Re: Newmar Corporation – Motor Vehicle Recall Notification

Subject: Recall Campaign No.: 08V-443

TSB 355

**Subject:** Missing heat shielding for engine exhaust.

Figure 1: No heat shield installed

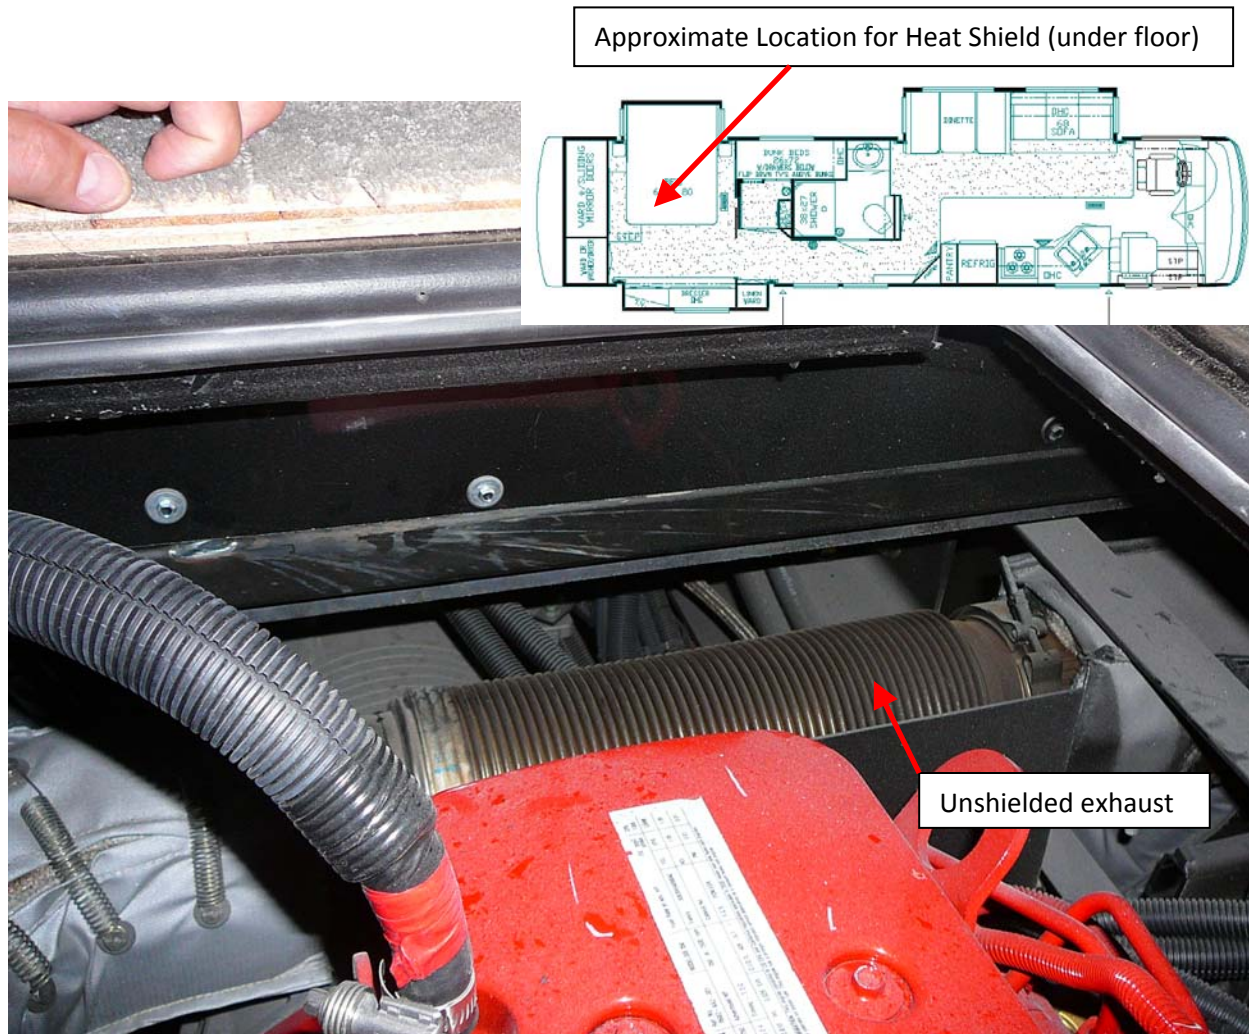
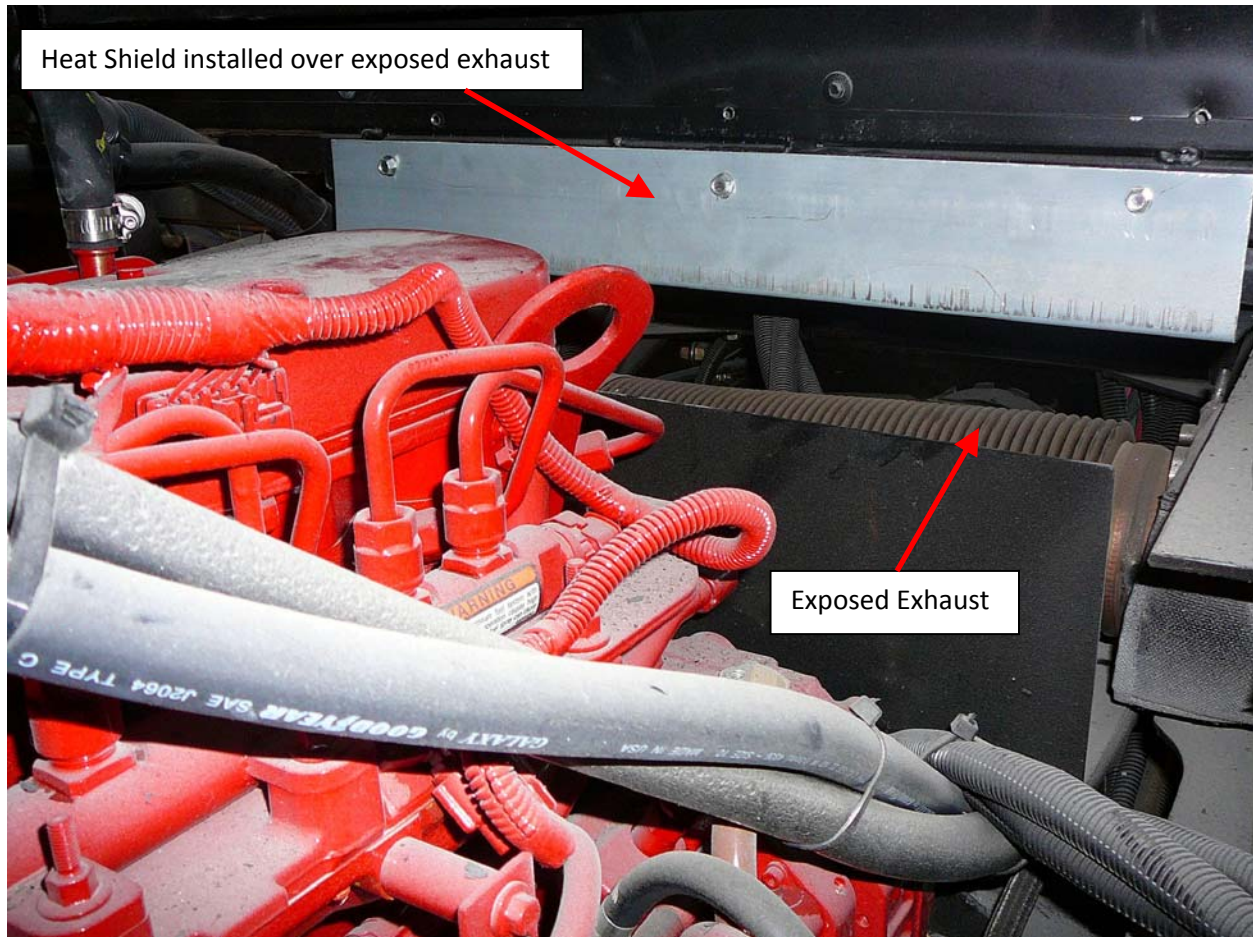
**Diagnosis Procedure:** Move any obstructions, and open the engine access located in the floor. Look forward toward the front end of the engine compartment. Look for the heat shield on the cross member that is located just below the engine access opening. This heat shield will be installed on the cross member. Figure 1 shows the unit without a heat shield, figure 2 shows the unit with a heat shield installed.

If a heat shield is not present you will need to install one to redirect the heat. Use **ONLY** the specified Heat Shield (Newmar part #112234) for this recall.

Figure 2A

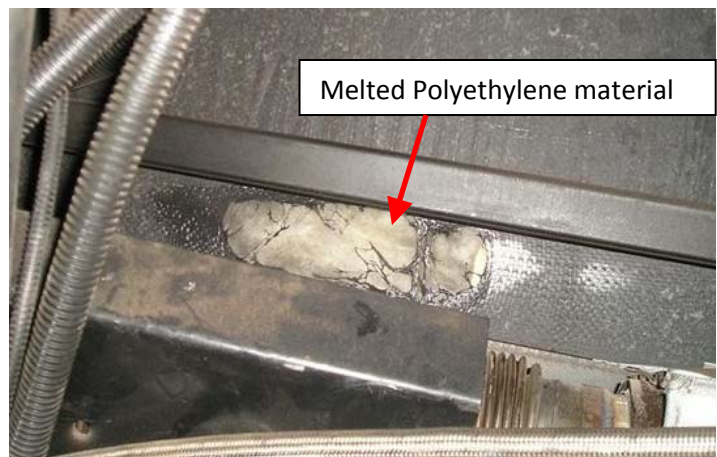
Before installing the heat shield, inspect the polyethylene vapor barrier above the exhaust for signs of heat damage. If the vapor barrier has been heat damaged, it will need to be repaired prior to installing the heat shield (see figure 2A).

If a repair is required, Newmar recommends installing a piece of .030 aluminum or galvanized steel, cut to fit, and secured into place with screws and silicone as necessary. This patch may need to be 17-33 in. by 3-4 in. and must be fastened directly to the stringers between the structural cross-members forward of the engine compartment. Clean any dust, dirt, or road debris from the area to be repaired, then install the cover into place over the damaged section. Inspect the repair to be sure it is thoroughly covering the damaged area, and is properly secured to insure it will not fall off.

Figure 3

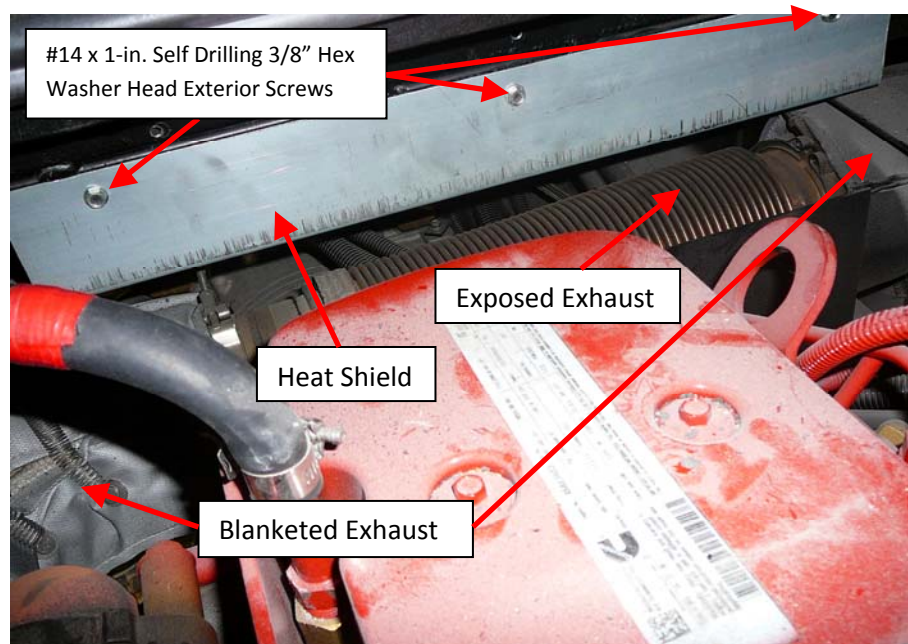
Position the heat shield over the exposed exhaust and fasten it into place using three #14 x 1-in. Self-Drilling 3/8" Hex Washer Head Exterior Screws. Position the heat shield so as to cover the entire exposed area of the engine exhaust (Figure 3).

It is important to make sure the heat shield is properly positioned to insure it covers the area of exposed exhaust. The exhaust on either side of the exposed section is blanketed and does not require shielding.

Figure 4: Check for contact / chaffing

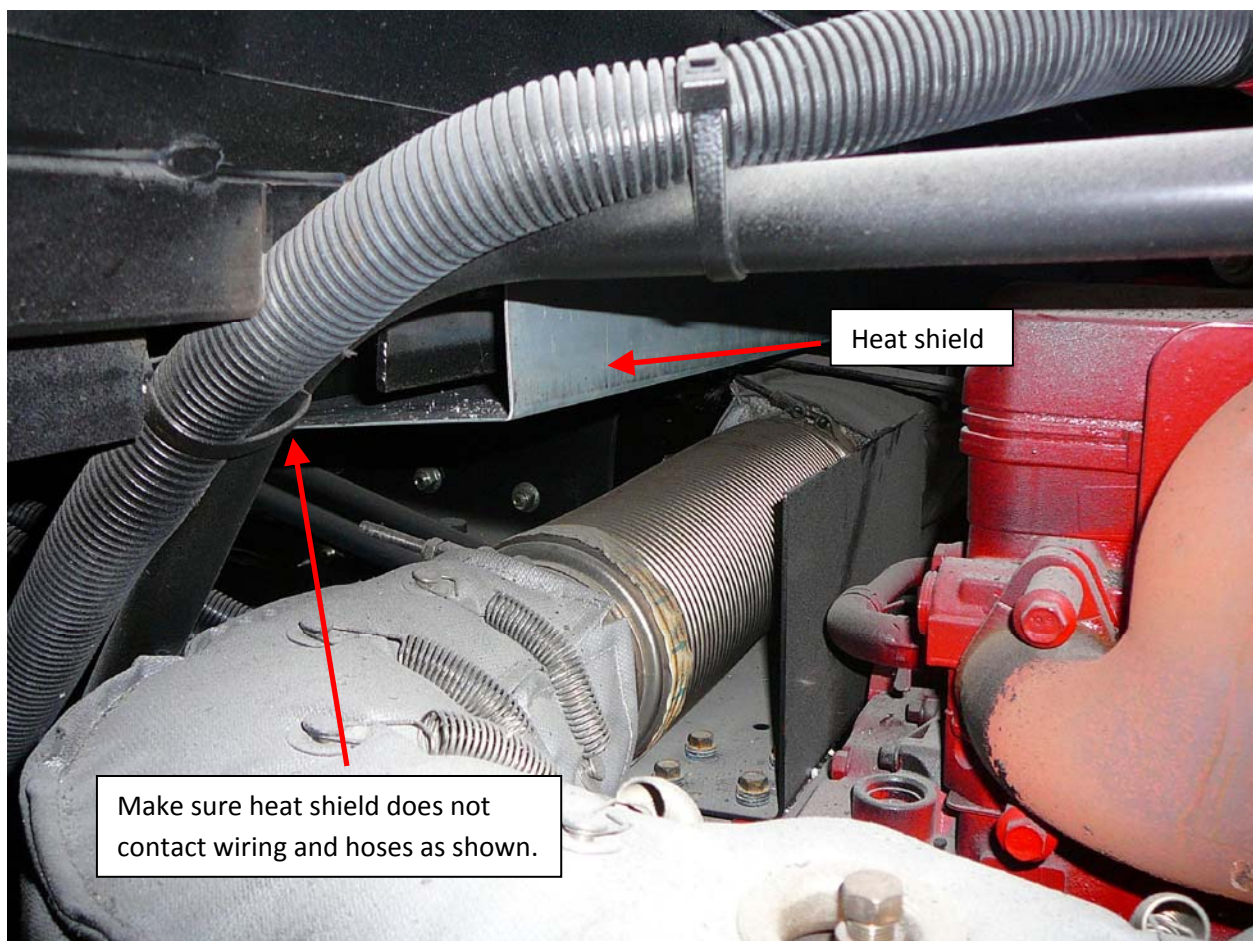
**IMPORTANT:** Once installed, be certain the heat shield is not rubbing against or chaffing any surrounding wiring, hoses, or other items in the engine compartment (Figure 4). Contact with wiring, hoses, and other items will cause excessive wear and potential failures in those components. If the heat shield is properly positioned (over the exposed exhaust between the two existing heat blankets) and there is physical contact between the shield and any wiring or hoses in the engine compartment, reposition the wires or hoses and tie them back to prevent chaffing. Positioning the heat shield properly between the heat blankets and over the exposed exhaust is critical to this repair.
